Executive Director's Recommendation

Commission Meeting: March 6, 2025

PROJECT Tidal Basin Development Concept Plan National Mall and Memorial Parks Tidal Basin Washington, DC	NCPC FILE NUMBER MP314 NCPC MAP FILE NUMBER 1.51(05.00)45962
SUBMITTED BY United States Department of the Interior, National Park Service	APPLICANT'S REQUEST Approval of comments on concept master plan
REVIEW AUTHORITY Approval of Master Plans for use by the Commission per 40 U.S.C. § 8722(a) and (b)(1)	PROPOSED ACTION Approve comments on concept master plan ACTION ITEM TYPE Staff Presentation

Site section showing transect of roadway, tiered seating area, and cantilevered walkway at northeast edge of Tidal Basin.

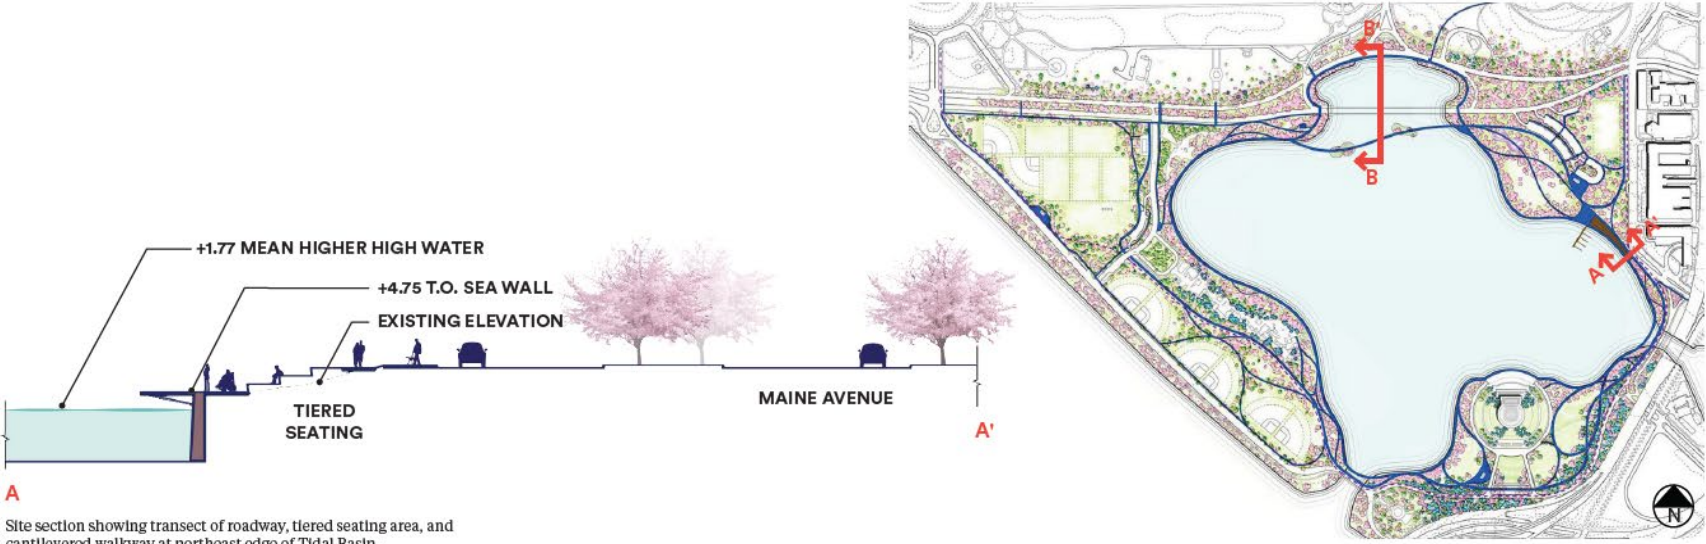
Supports the potential use of cantilevered walkways along the Tidal Basin seawall as shown in alternatives **A and B** and **requests** the applicant provide an analysis of the criteria used to refine their locations.
